# CROSSROADS AT MEADOWBROOK-MIXED USE PRELIMINARY PLAN

LOCATED IN THE SOUTHWEST 1/4 OF SECTION 8, T14S, R65W, OF THE 6th P.M., EL PASO COUNTY, COLORADO

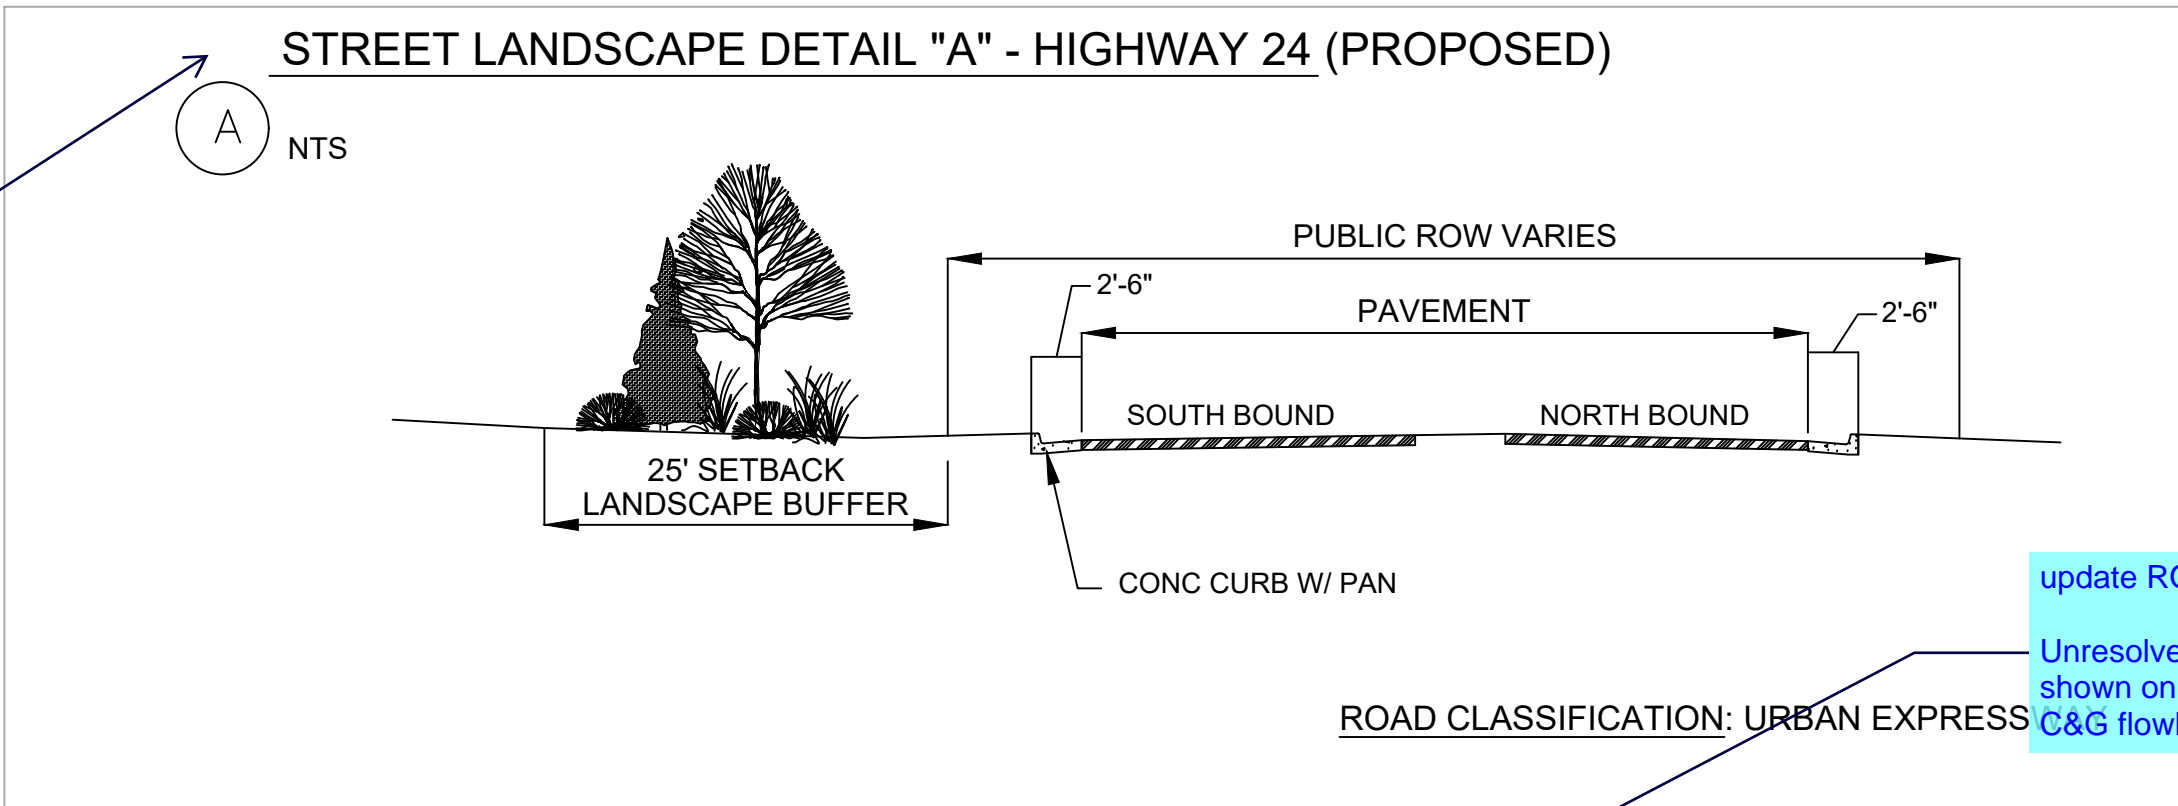
Contact the review engineer if you need clarifications on any comments provided below.
